PRESERVE AT JONES DAIRY - CENTRAL CONSTRUCTION DRAWINGS
 ROLESVILLE, NC
FIGHTING BULL DRIVE PLAN AND PROFILE

PROJECT NO: ---
 DESIGN BY: JPE
 DRAWN BY: RSF
 SCALE: 1"=50'
 DATE: 2023-01-27
 SHEET NO: **P4.2**

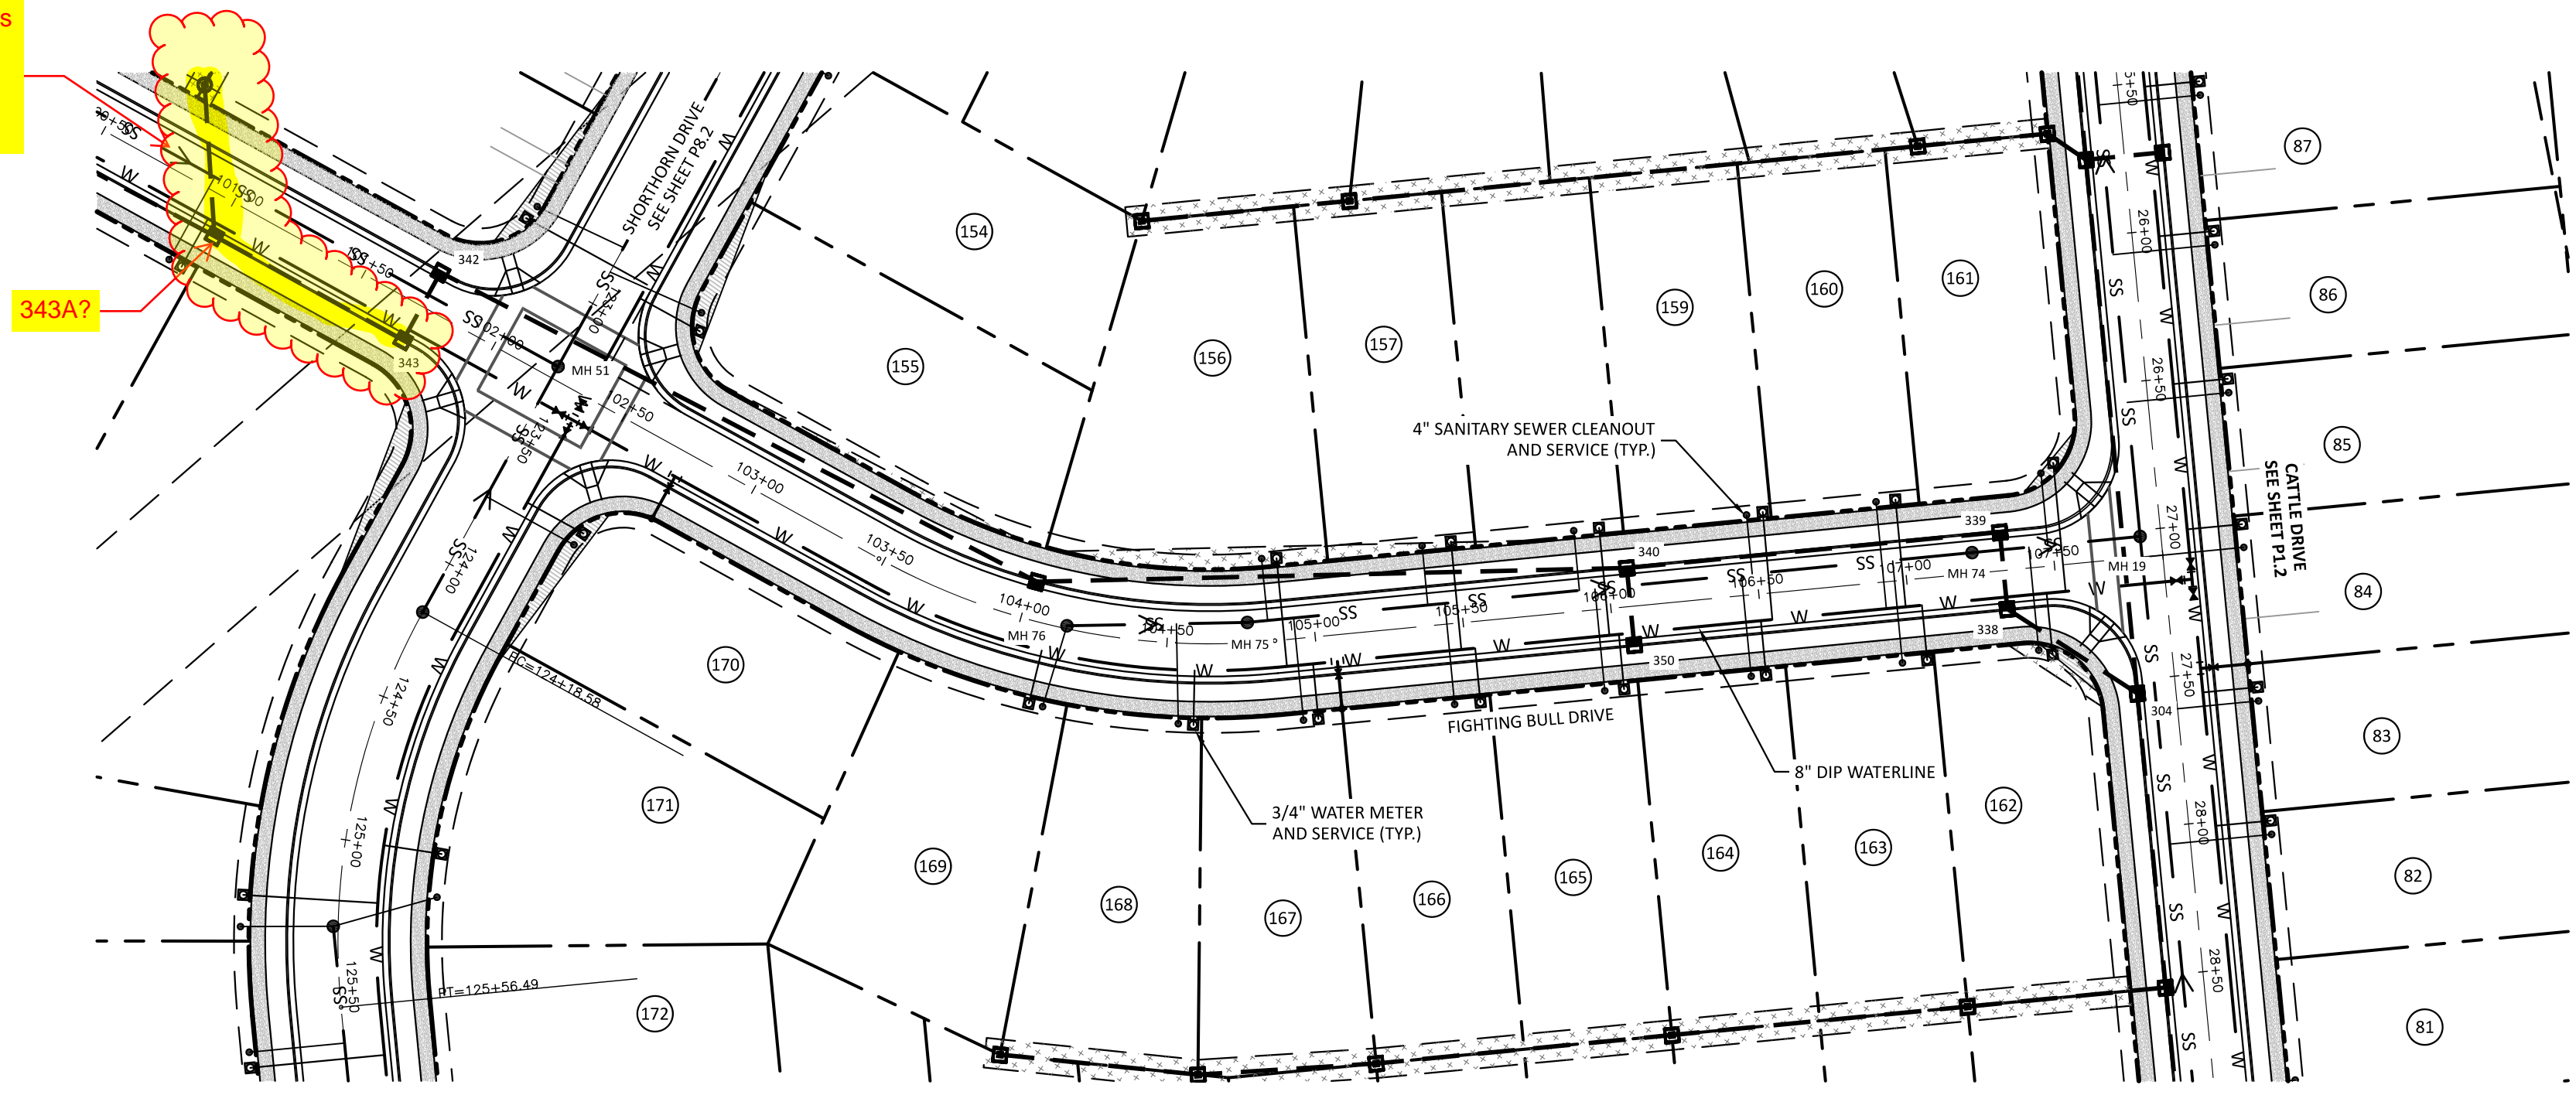
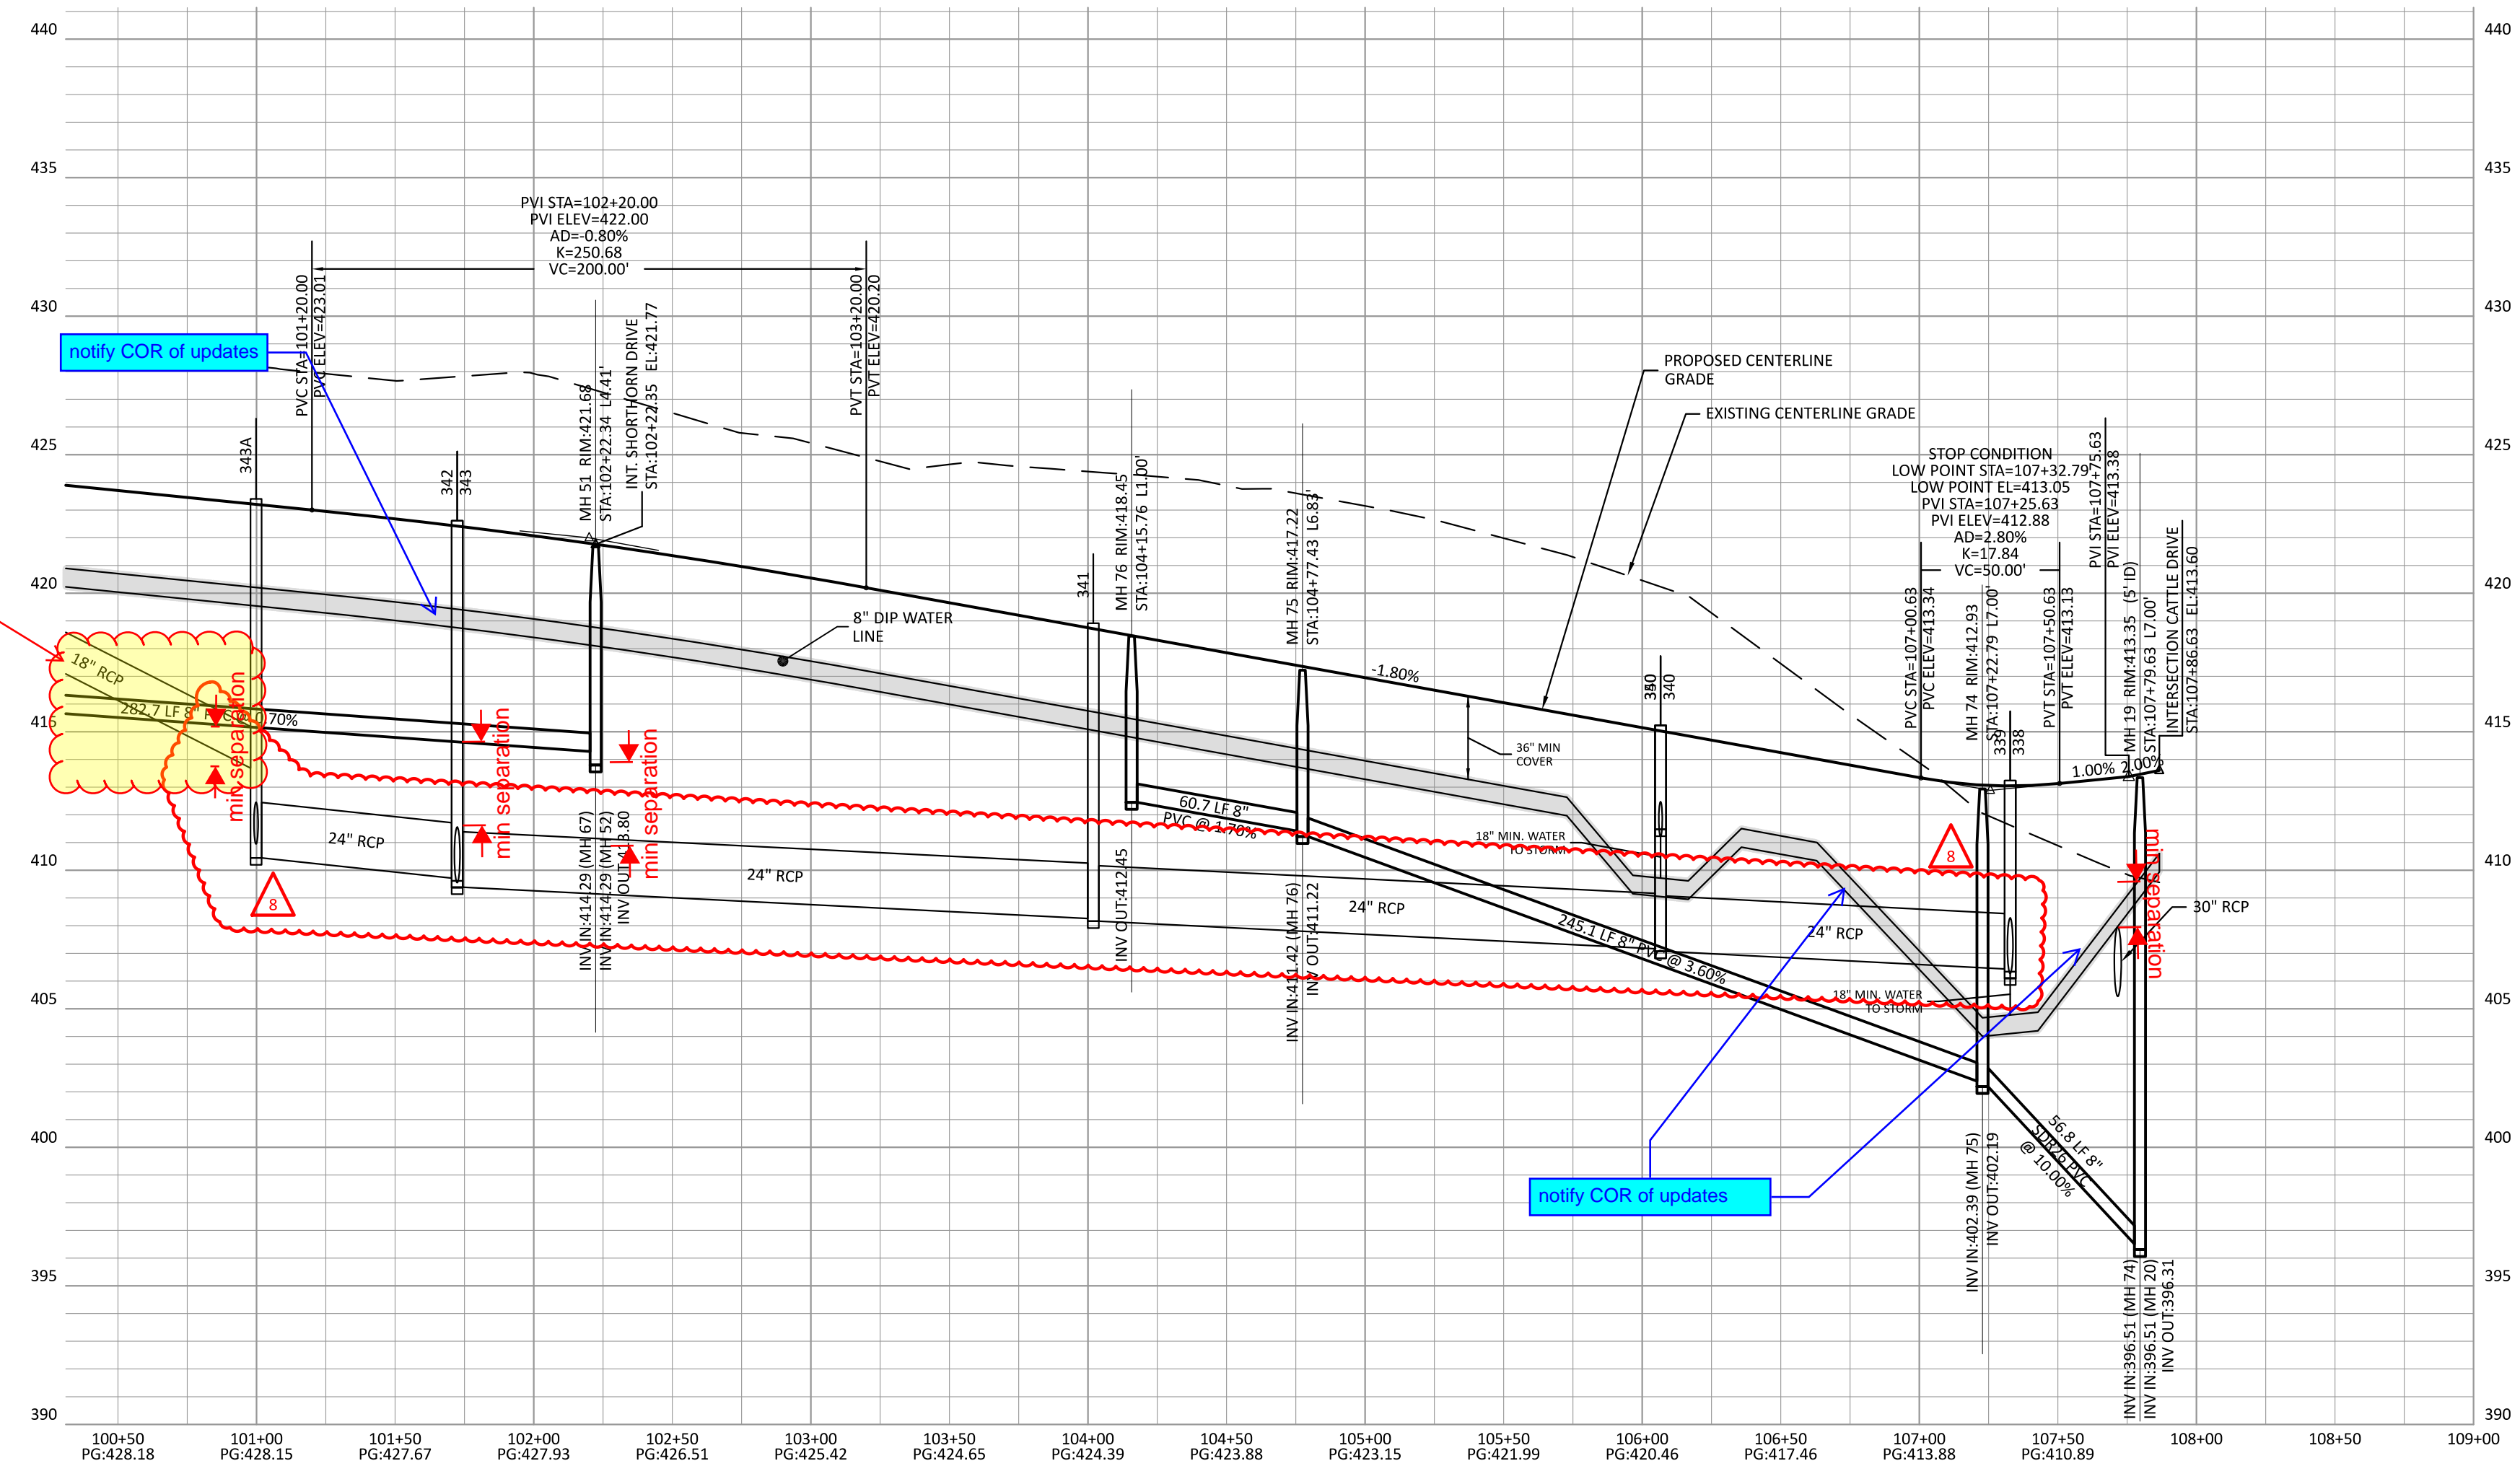
7. Label all structures shown in the profile and show pertinent crossings in the profile.

8. Sewer and Storm cross but are at the same elevation.
